RE: Chen residence Mercer Island City file 2102-184

What follows are the answers to posted comments with those original comments included as requested. Photographs of trees 518-9 included.

ARBORIST TREE PLAN

A102

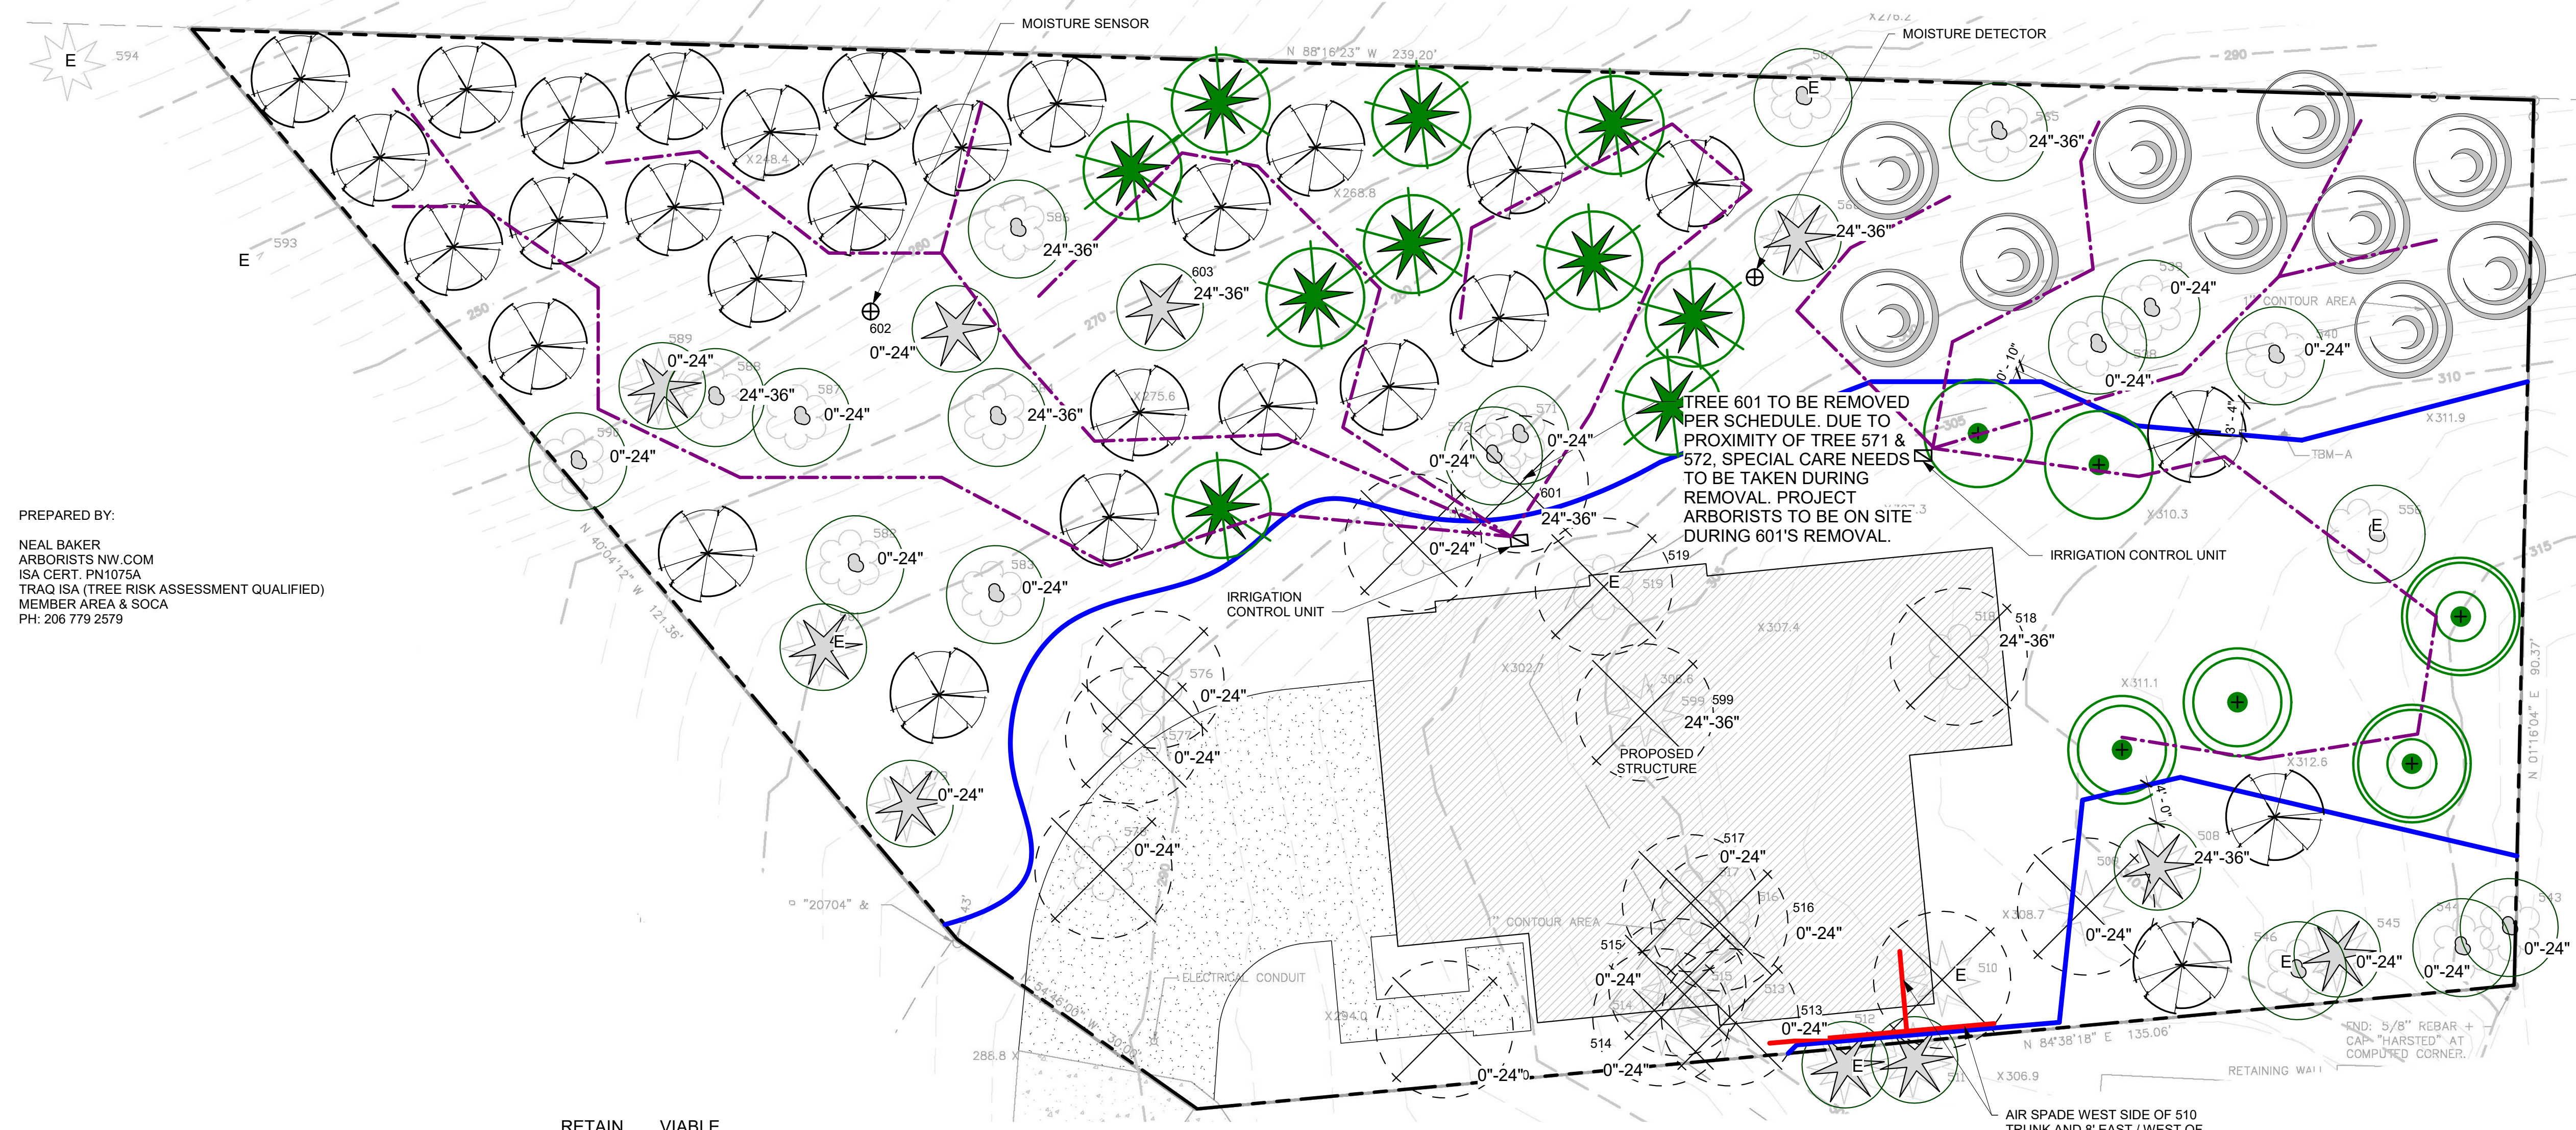
“3.(Repeat comment from pre application meeting for Civil) Tree plan to be shown with all Civil and Arborist information. See above checklist that includes the following items provide at initial meeting. Identify Exceptional trees using different symbols for trees less than 24 inches and trees greater than or equal to 24 inches. Indicate clearing limits/limits of disturbance (LOD) around all trees potentially impacted by site disturbances - grading, demolition, construction activities (including approximate LOD of off-site trees with overhanging driplines), etc. An outdated tree protection diagram is shown on the TESC plan, Call out to check sheet A102 for tree protection diagram.[https://www.mercerisland.gov/sites/default/files/fileattachments/community\\_planning\\_amp\\_development/page/21988/treessubmittalchecklist.pdf](https://www.mercerisland.gov/sites/default/files/fileattachments/community_planning_amp_development/page/21988/treessubmittalchecklist.pdf)”

“4.(Repeat comment provided at Intake Review for Arborist/Civil/Architect) Tree 508 is exceptional and to be saved. However, tree protection is shown 8 feet from the face of the tree. This is inadequate and would probably result in the tree being damaged and removed. The Arborist gives the dripline at 40', is this a radius? It is unclear and this tree is not described in the report only a graphic on the plan. Tree 579's dripline is not to scale. Tree protection is shown 11' away while the dripline is 28' (assumed in radius). Confirm tree protection conforms with MICC19.10.080. The arborist must show my comment and then respond to it in a clear way, so I know they have received my comments. Any exceptional trees that would be damaged or removed need justification under MICC19.10.60.A.3. Tree protection needs to be shown at the critical root zone/dripline. No new grading that is shown on sheet A101 will be allowed within this tree protection area.”

"5(forArborist/Geotechnical Engineer) No watering/irrigation information was provided with the replanting plan. Include a pla preferably with temporary drip irrigation. This irrigation plan shall comply with your Geotechnical Engineers recommendations."

1. Symbols for the different size trees, such as exceptional and trees in other size ranges, have been differentiated With LOD and clearing limits as requested. Where practical individual LOD are grouped behind tree protection measures, these updates are called out on sheet A102. These are the responses to the comments below.

Regarding Tree 508: Tree protection measures have been adjusted to show the full protection of the tree (sheet A102). The dripline for tree 579 has been re-scaled as required with appropriate tree protection locations. These are the responses to the comments below.

An irrigation system has been designed for the temporary care of the trees. It consists of soaker hoses placed to get water to each new replacement tree. There are four zones with controllers that include water sensors to eliminate over-watering and wasteful runoff. See sheet A102 for more detail. These are the responses to the comments below.
